Subject: Amend a previously approved COA to elevate the house above the

base flood elevation.

Certificate of Appropriateness Staff Report

I. **Property Address**: 723 Yarmouth Street

Approved design with the conditions noted above

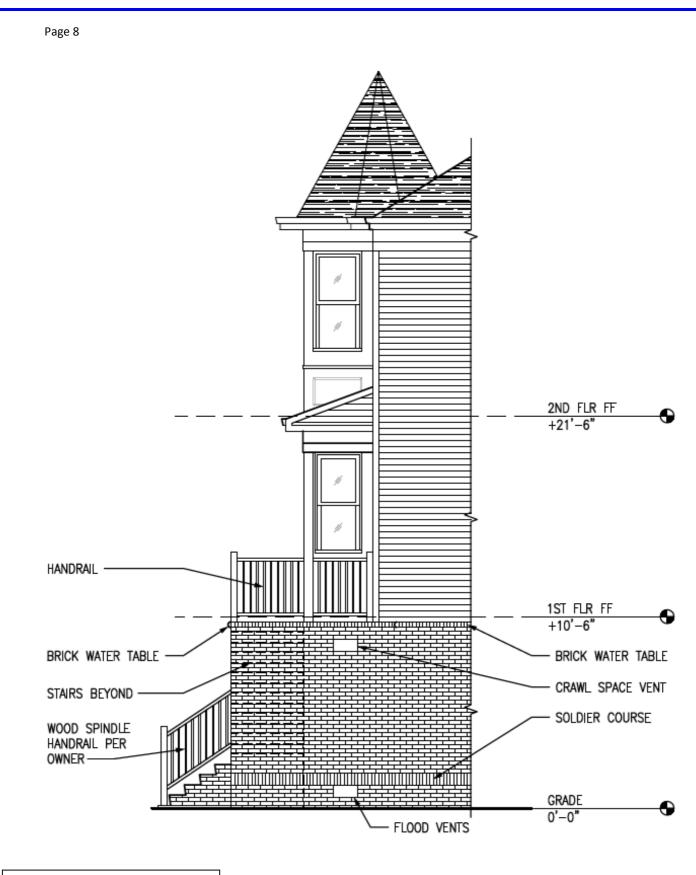
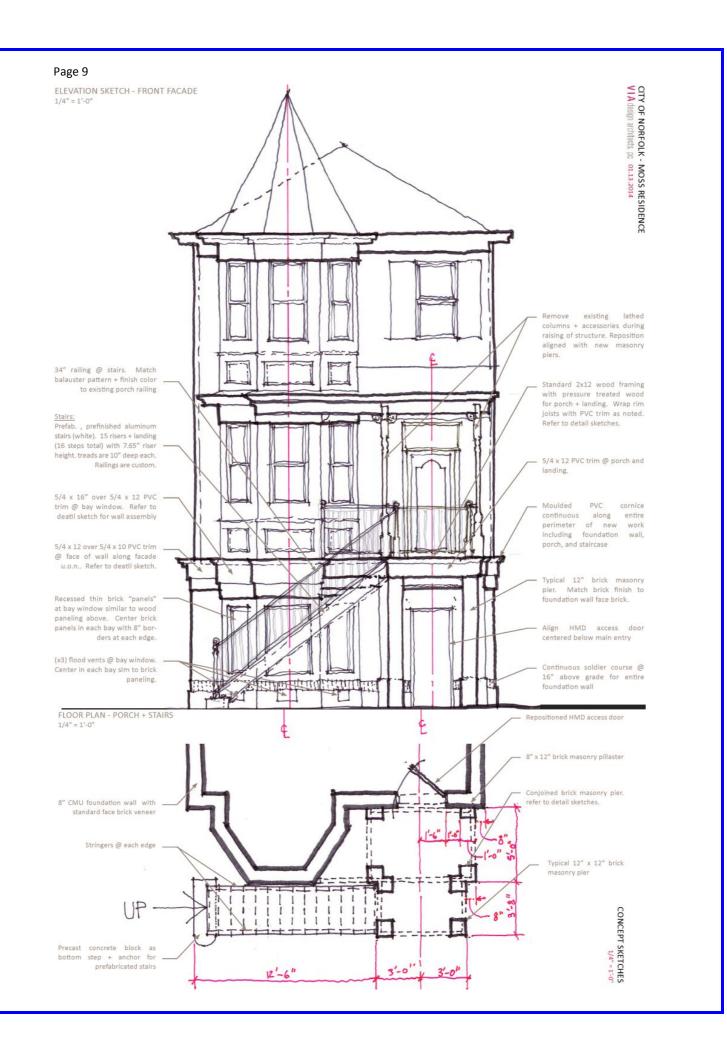
- The proposed foundation door in the front elevation shall be centered below the main entry door of the house, centerline-to-centerline
- There shall be a soldier course of brick above the proposed foundation door

- The flood vent that is shown in the foundation door on the elevation shall be moved to the right of the door
- The proposed foundation door may be in a material other than wood in this case only due to the repetitive flooding of this location and the expectation that the door will be partially submerged several times per year

- The foundation door shall have no arch in the panels and be painted white to match the trim
- All of the new rail system for the stairs and porch shall match the existing pattern on the porch but be sized to meet the present building code requirements and be made out of wood

- The new stairs and landings will be brick to match the pattern that was submitted
- The brick and mortar that was submitted are approved

Site Survey - Enlarged

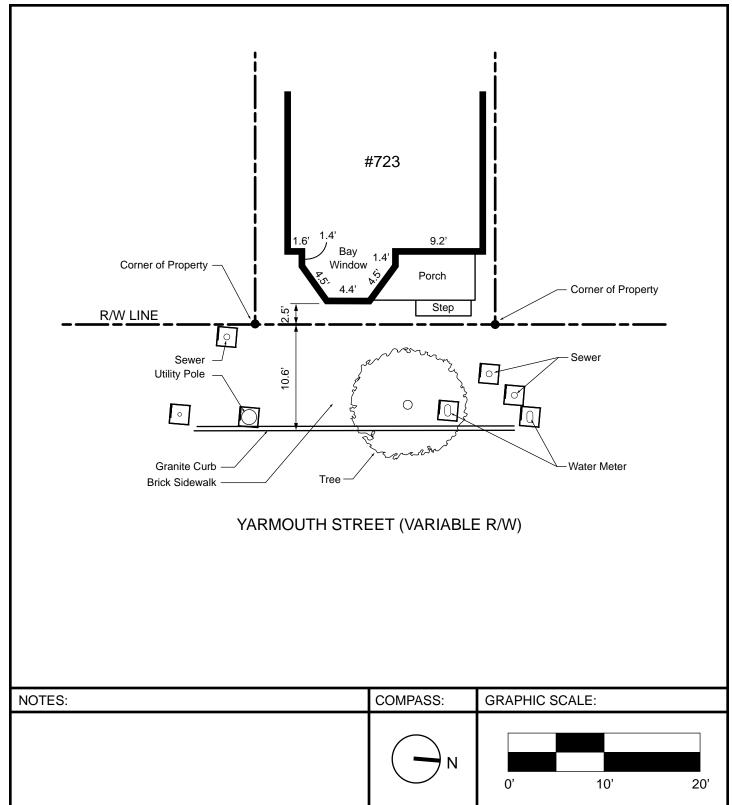
There is only 2.5' (2'-6") distance between property line and face of building. Footprint for any proposed staircase ascending 10.5' (10'-6") height will encroach upon public sidewalk.

Refer to enlarged survey for additional measurements, utilies placement, and existing landscaping elements.
